Docket Number:	19-BSTD-03
Project Title:	2022 Energy Code Pre-Rulemaking
TN #:	234346
Document Title:	Naphn Comment on Proposal to Derate Heat Recovery Ventilators
Description:	Passive House comment letter regarding proposed change to heat recovery ventilator credit submitted to docket per request made by Commissioner McAllister
Filer:	Adrian Ownby
Organization:	North American Passive House Network (Naphn)
Submitter Role:	Public
Submission Date:	8/18/2020 1:29:58 PM
Docketed Date:	8/18/2020

Re: “HRV White Paper on Revisions to HRV Standard Designs and Modeling: CBECC-Com and CBECC-Res 2019.2.0” A proposal to derate the credits assigned to HRV’s.

Image source: PHCA's website article - CASE Passive House Low-rise Multifamily Reach Code Delivers Results!

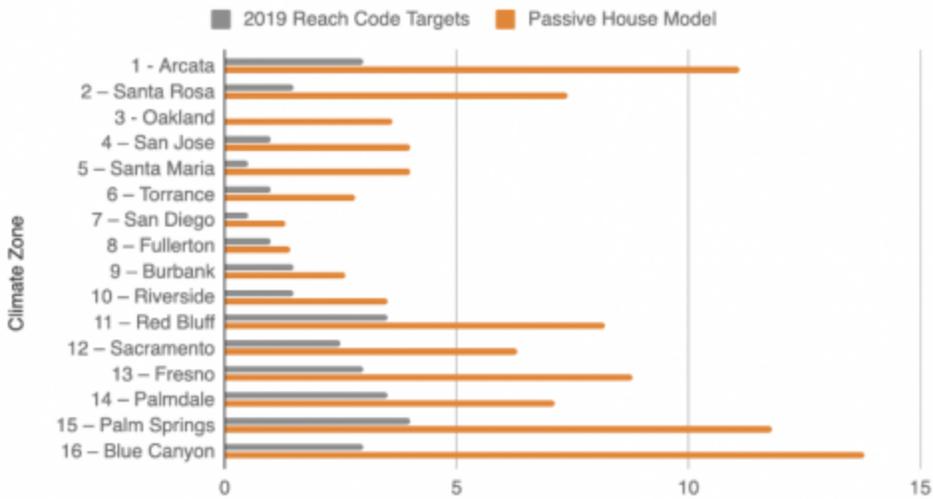
As part to the 2019 Low-Rise Multifamily Reach Code proposal reviewed and vetted by Codes and Standards earlier this year, Passive House California (PHCA) confirmed that low-rise multifamily buildings designed and built with HRV’s with measured efficiency capture above 75% would far exceed the EDR margins currently required for 2019 Reach Code targets. We found that while not all climates in California require the heating/cooling energy recovery, they all benefit from their use. *This offers surprising cost-effectiveness opportunities to developers once they discover that heating equipment may be eliminated in particular climates.*

Image 2: Comparative testing results for three HRV's showing HVI results (in red) compared to DIN V 18599-6:2007-02 and DIN EN 13141-7:2004(D) testing protocol results. Info source: Mr. Eberhard Paul, ZehnderPaul.

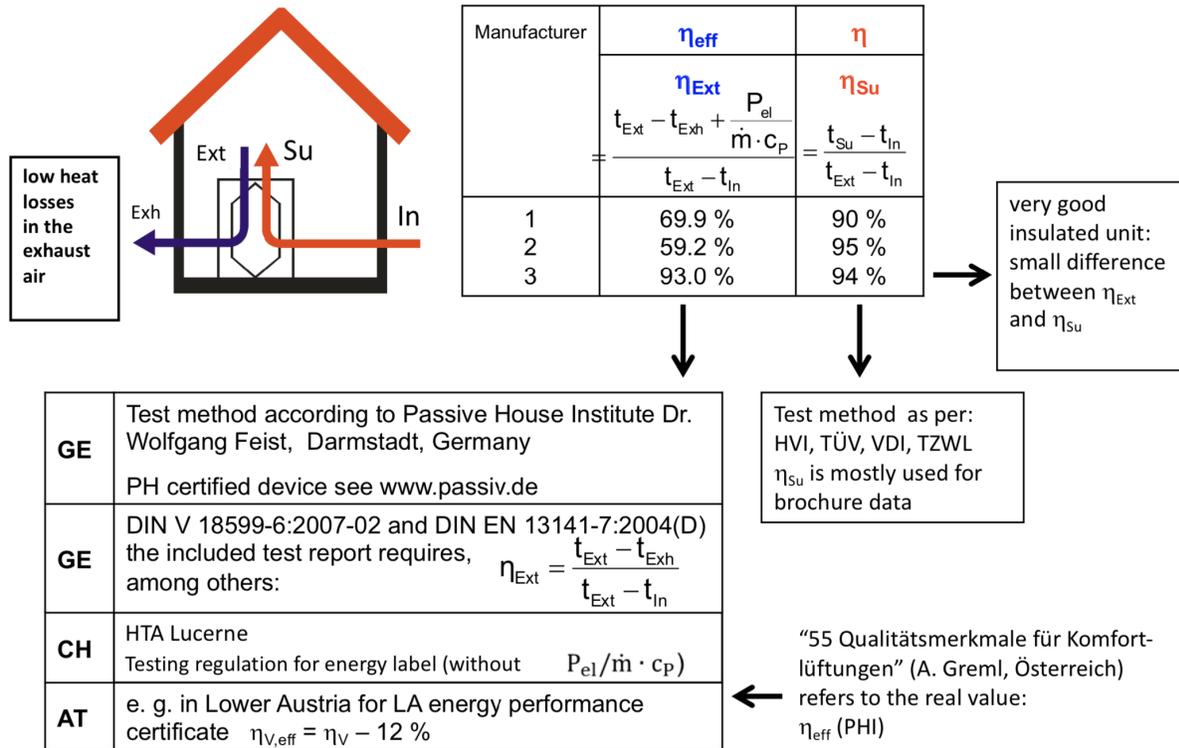
While we support and appreciate the valuable service that the Home Ventilation Institute (HVI) has provided to the industry as the need for, and accurate assessment of mechanical ventilation has grown, we humbly submit that their testing methodology could and should be updated. A deviation in how effective recovery of HRV's is measured exists between HVI's testing protocol and that used by a number of HRV testing protocols commonly used in Europe, including that used by the Passive House Institute. The difference hinges upon which location in the ventilator that the heat recovery is measured: HVI measures this at the outflow, while the other commonly accepted protocols (including that used by the Passive House Institute) measure at the point of extraction.

The graphic included below shows results for three separate HRV units from different manufacturers when tested using the two protocols. The η_{Ext} results vary significantly for the less effective units, compared to the η_{Su} results for the same units.

Image 3: Comparative testing results for moderately efficient HRV's showing HVI results (in red) compared to DIN V 18599-6:2007-02 and DIN EN 13141-7:2004(D) testing protocol results. Info source: Mr. Eberhard Paul, ZehnderPaul.

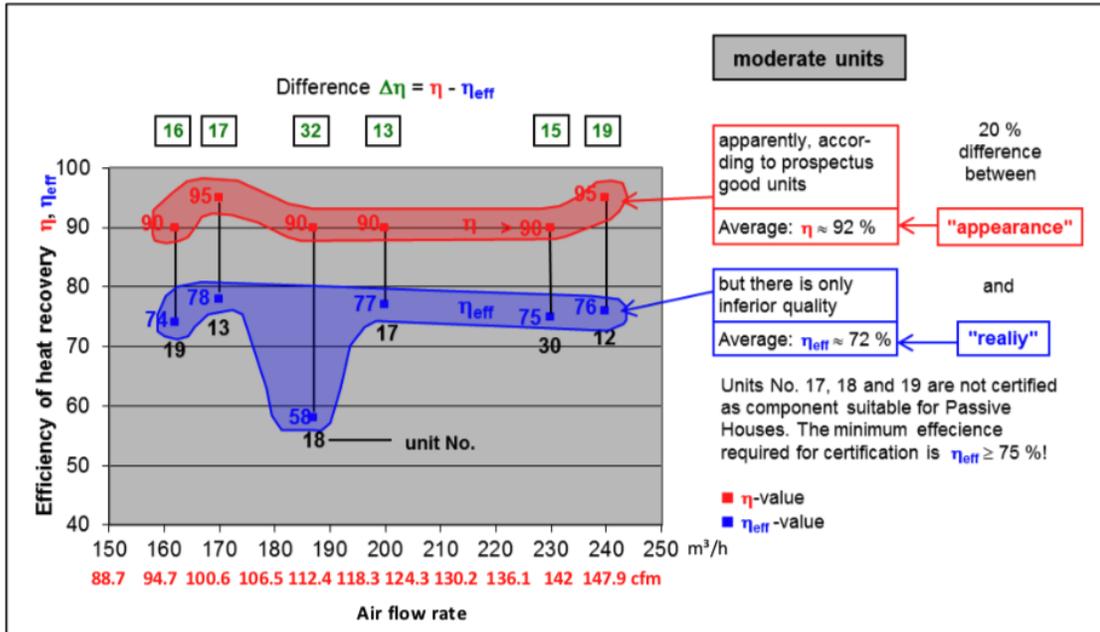
In a series of tests run by the staff at Zehnder/Paul, Germany, on a larger number of HRV's, the inconsistency of results using the two protocols was further confirmed. A deviation in results was found to be particularly pronounced for moderately efficient units.

Image 4: Comparative testing results for highly efficient HRV's showing better alignment in HVI results (in red) when compared to DIN V 18599-6:2007-02 and DIN EN 13141-7:2004(D) testing protocol results.
Info source: Mr. Eberhard Paul, ZehnderPaul.

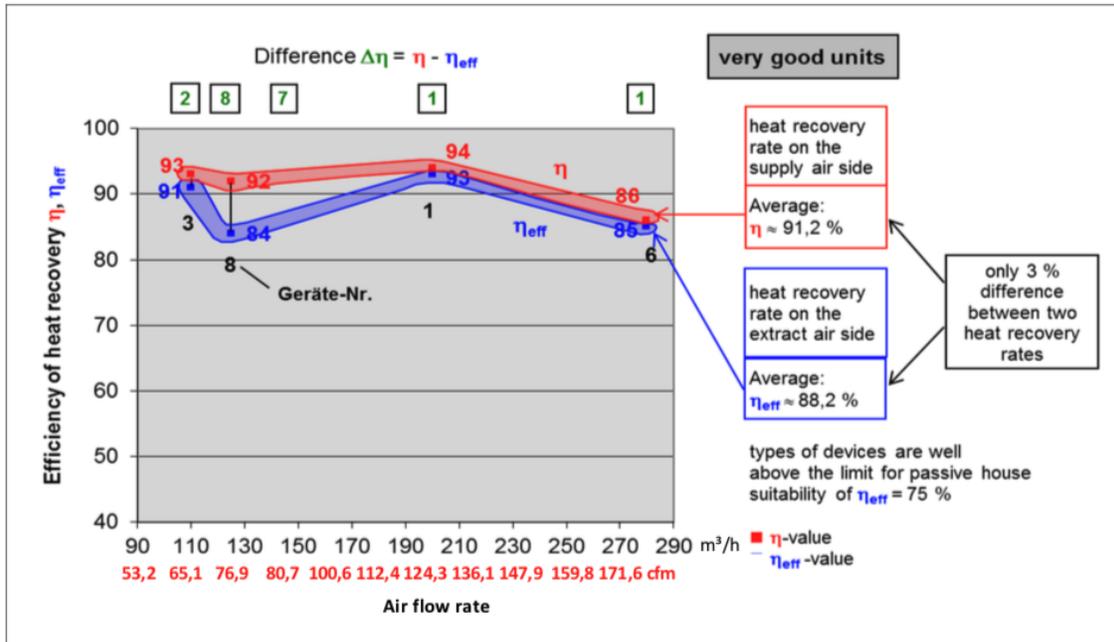
When units rated with much higher effective capture efficiency were tested, results became more aligned in both protocols. These results support our proposal above to **consider providing higher credit points for units with effective recovery efficiencies above 80%, and underscore our motivation to modify HVI testing protocols, or accept alternate testing protocols for E/ERV's.**
